**City of Portland, Maine – Building or Use Permit Application** 389 Congress Street, 04101, Tel: (207) 874-8703, FAX: 874-8716

Location of Construction: 26 Sunset Rd, Peaks Isl		Owner: Friedman, Philip & Karen		Phone:		Permit No <b>970705</b> <b>PERMIT ISSUED</b> Permit Issued: <b>JUL - 3 1997</b> <b>CITY OF PORTLAND</b>
Owner Address:		Lessee/Buyer's Name:		Business Name:		
Contractor Name: Weigel Construction,		Address: Inc. 2 Glen Rd Falmouth, ME 04105		Phone: 781-5569		Zone: <b>2</b> CBL: <b>090-D-014</b> Zoning Approval: <b>7/2/97</b> Special Zone or Reviews: <input checked="" type="checkbox"/> Shoreland <i>within 75' of HWY</i> <input type="checkbox"/> Wetland <input type="checkbox"/> Flood Zone <i>panel 15 - Zone C</i> <input type="checkbox"/> Subdivision <input type="checkbox"/> Site Plan maj <input type="checkbox"/> minor <input type="checkbox"/> mm <input type="checkbox"/>
Past Use: 1-fam		Proposed Use: Same		COST OF WORK: \$ 26,000.00 PERMIT FEE: \$ 150.00 FIRE DEPT. <input type="checkbox"/> Approved <input type="checkbox"/> Denied INSPECTION: Use Group: <b>R3</b> Type: <b>5B</b> Signature: <i>[Signature]</i> Date: <i>[Signature]</i>

Proposed Use/Work - New addition (

**MORTGAGE SURVEY PLAN**

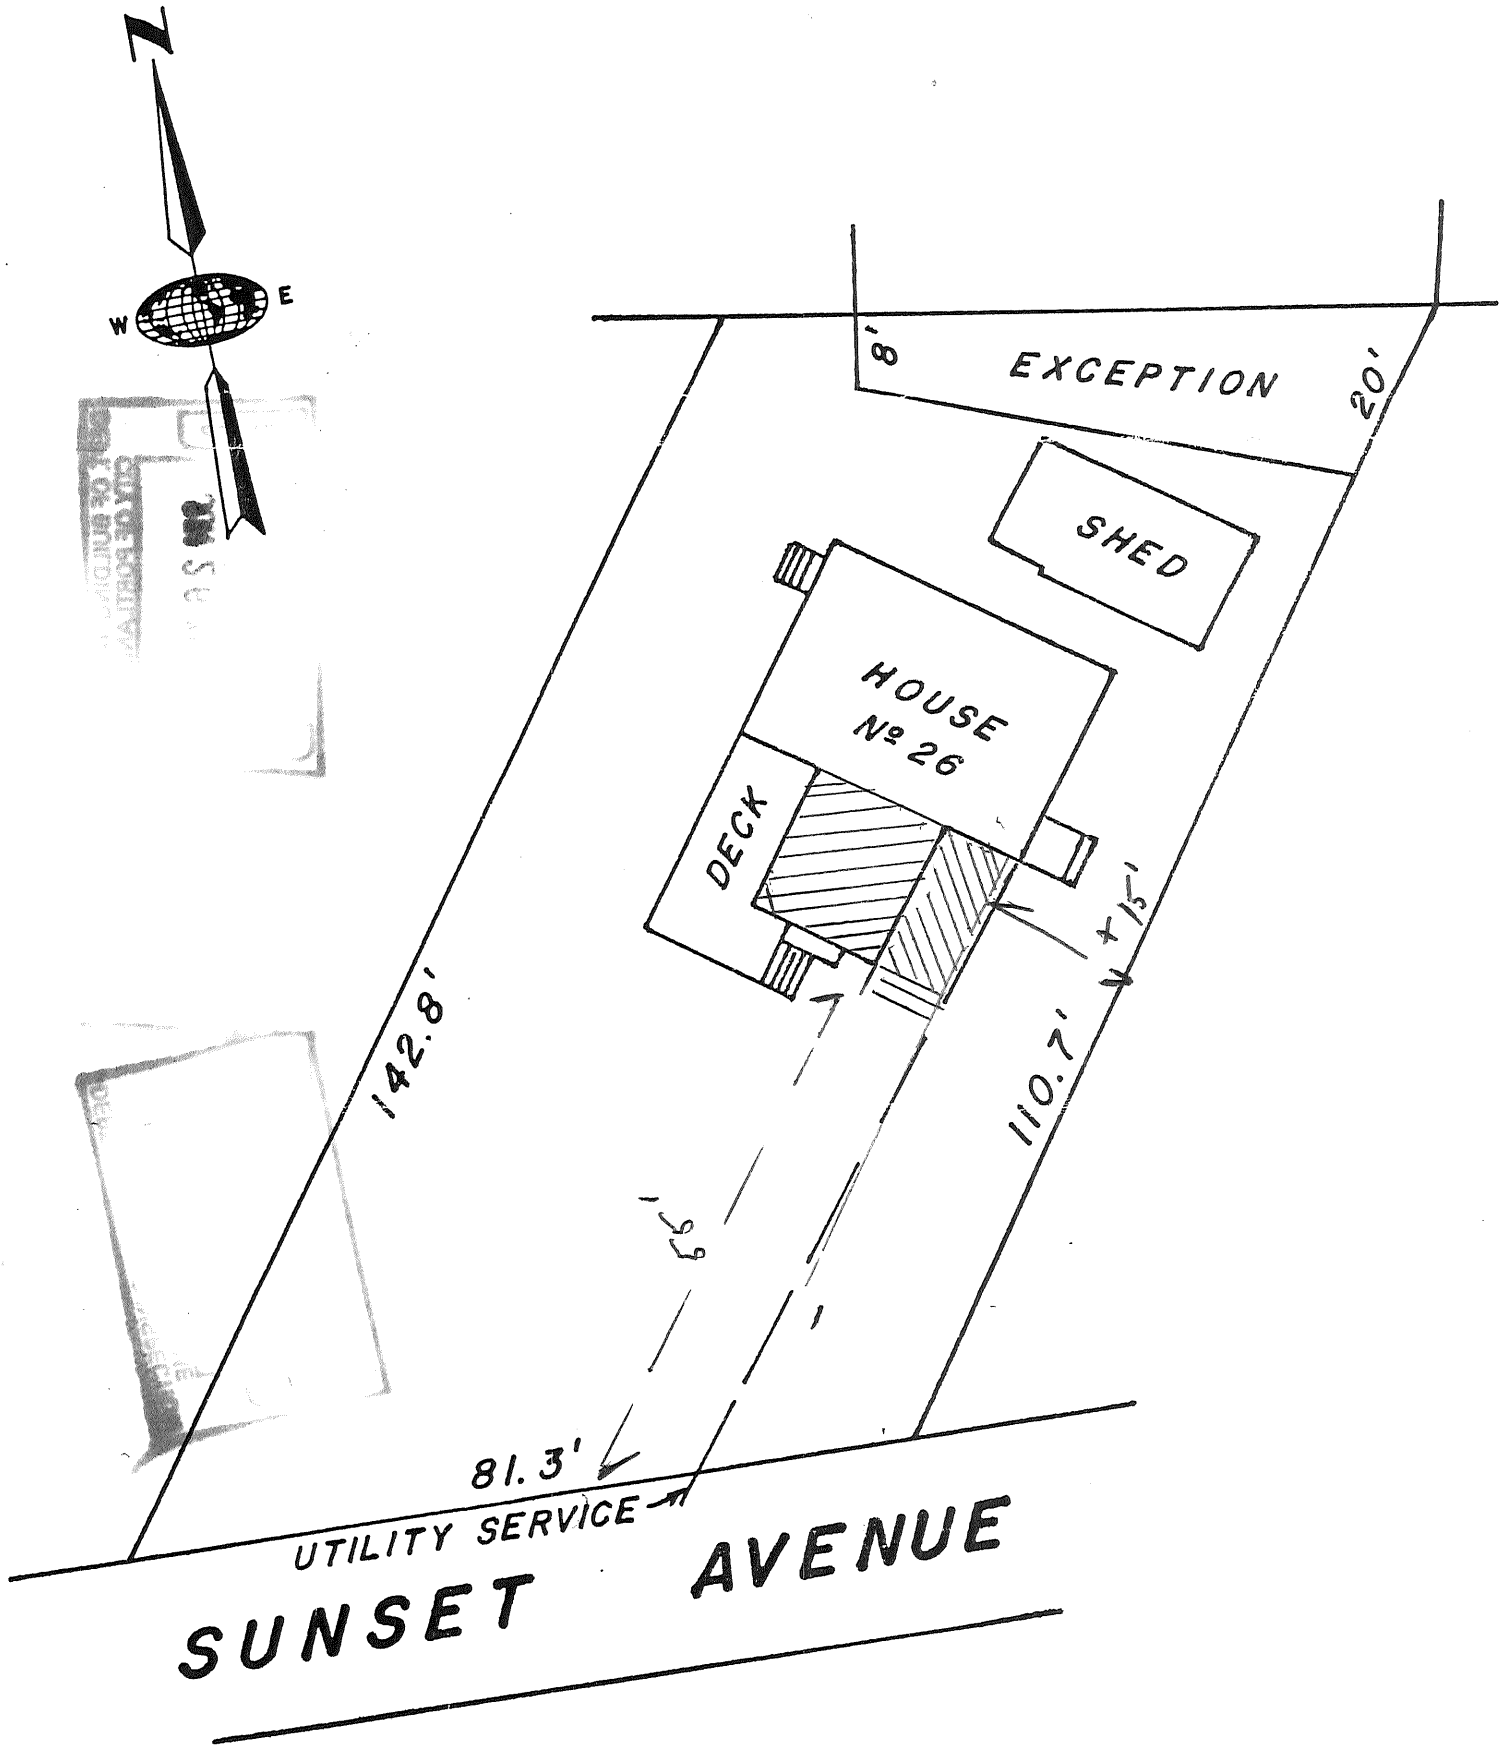
Height - Shows 20' to ridge at the highest point

yes with in 75' but over 75' to High Water Mark

14-436 Section utilized to go up and to allow deck fill in can not extend further out from bldg lines on side or front
